Agenda Item # 4

SUB-003473-2025

Crestwood B Subdivision

- Subdivision approval to create two (2) legal lots of record from one (1) metes-and-bounds parcel.

DETAIL SITE PLAN

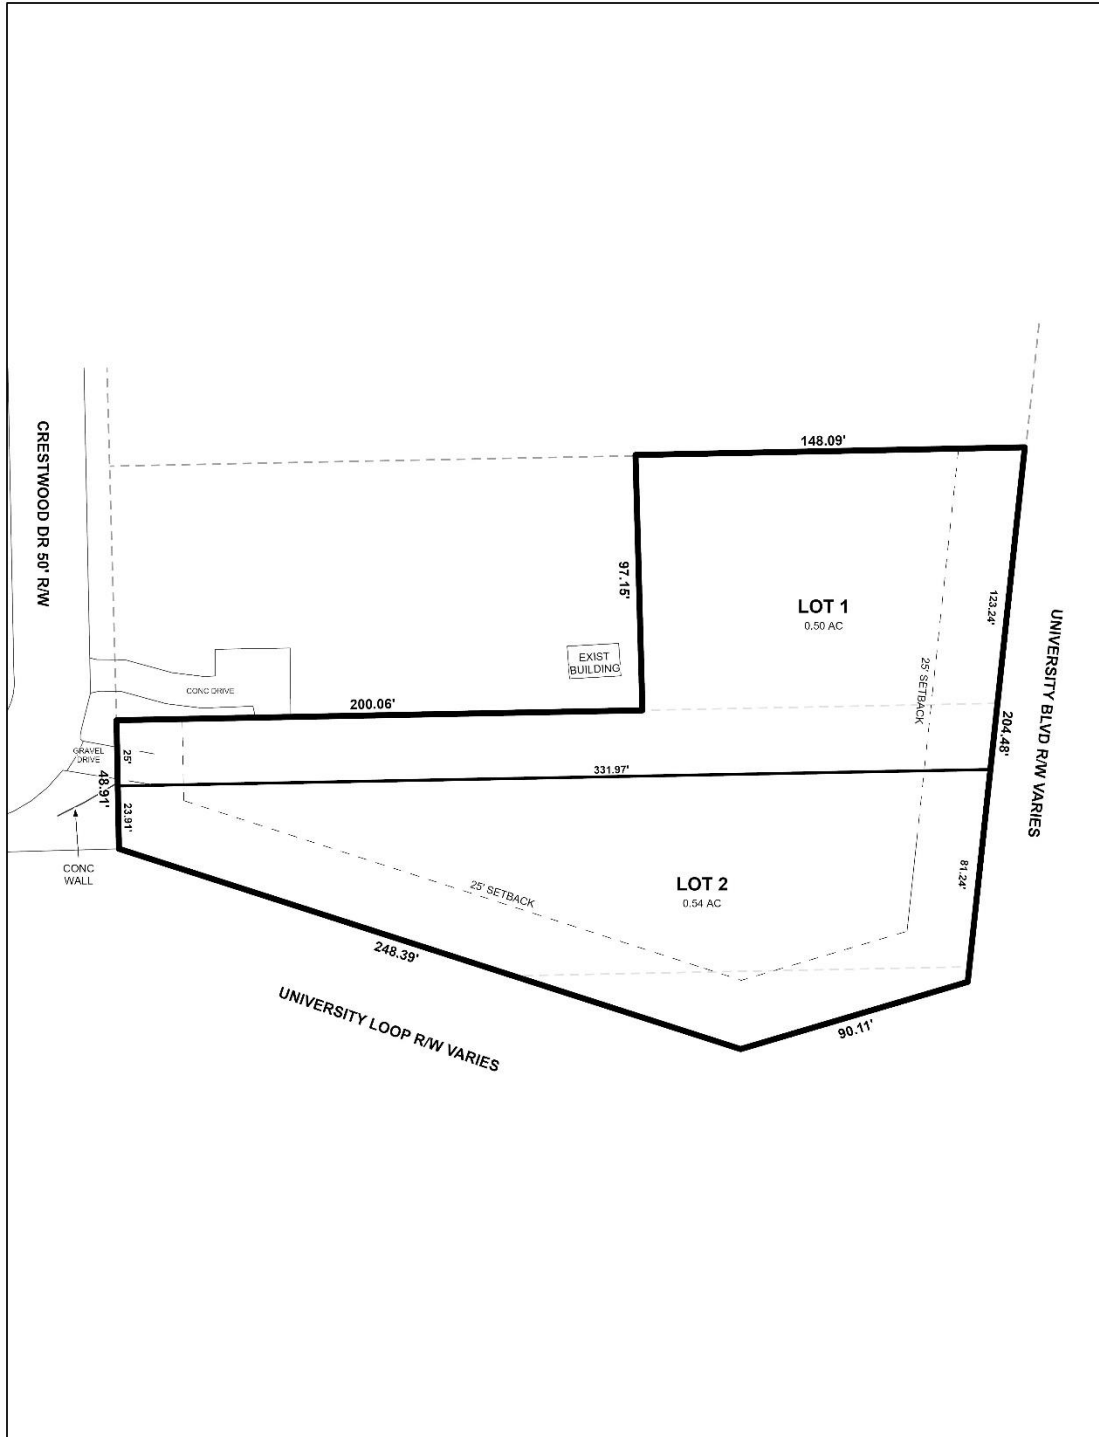
- B. Label "LOT 7" that is listed as the POB.
- C. Add the bearing and distance for the western property line of the subdivision that is common to both LOT 1 and 2. Check that it matches the written bearing and distance provided in the written description.

- D. Retain NOTES 5, 6, & 9 – 11.
- E. Add a note to the SUBDIVISION PLAT stating that as shown on the 1984 aerial photo LOTS 1 and 2 will receive historical credit of existing (1984) impervious area towards stormwater detention requirement per Mobile City Code, Chapter 17, Storm Water Management and Flood Control) as follows: LOT 1 – NONE and LOT 2 – NONE. The two lots will share the 4,000 SF credit provided to the original lot as follows: LOT 1 – 2,000 SF, LOT 2 – 2,000 SF. Stormwater detention will be required for any additional impervious area on either LOT over the 2,000 SF.

The proposed Lot 1 illustrates a 25-foot width along Crestwood Drive. The proposed Lot 2 illustrates an approximate 24-foot width along Crestwood Drive. Section 6.C.2.(b)(2) of the Subdivision Regulations requires lots to be at least 60 feet wide at the building setback line. It should be noted that the proposed Lot 1 is a panhandle, or flag-shaped lot. According to Section 6.C.9.(a) of the Subdivision Regulations, flag lots are generally not allowed. The applicant has provided a letter stating that the highway department acquired right-of-way along University Loop and University Boulevard. This acquisition, according to the applicant, has resulted in reduced road frontage along

Crestwood Drive. Staff finds that any other configuration may result in a land-locked parcel because the lots do not have access to University Boulevard or University Loop. If approved, a waiver of Section 6.C.9.(a) will be required, but the plat should be revised to illustrate the 25-foot minimum building setback line where the lots are at least 50-feet wide, in compliance with Article 2, Section 64-2-5.E of the UDC and Section 6.C.8. of the Subdivision Regulations.

The preliminary plat indicates that the proposed lots will front three streets. Section 6.C.7. of the Subdivision Regulations discourages lots with multiple street frontages. Recent GIS imagery indicates a vegetative buffer exists along University Boulevard and University Loop with no known curb cuts. The site has maintained access exclusively from Crestwood Drive. Therefore, a waiver of Section 6.C.7. may be appropriate.

Finally, the plat should be revised to illustrate the required 25-foot front yard setback along all street frontages, not just Crestwood Drive, in accordance with Article 2, Section 64-2-10.E. of the UDC and Section 6.C.8. of the Subdivision Regulations, adjusted for any required dedication.

1. Retention of the right-of-way along Crestwood Drive on the Final Plat, as depicted on the preliminary plat;
2. Revision of the Final Plat to depict either the existing right-of-way width along University Boulevard and University Loop or dedication sufficient to provide 100-foot-wide rights-of-way, whichever is greater;

4. Revision of the Final Plat to illustrate a 25-foot minimum building setback line where each lot is at least 50-feet wide;
5. Revision of the Final Plat to illustrate the required 25-foot front yard setback along all street frontages, in compliance with Article 2, Section 64-2-10.E. of the UDC and Section 6.C.8. of the Subdivision Regulations, adjusted for any required dedication;
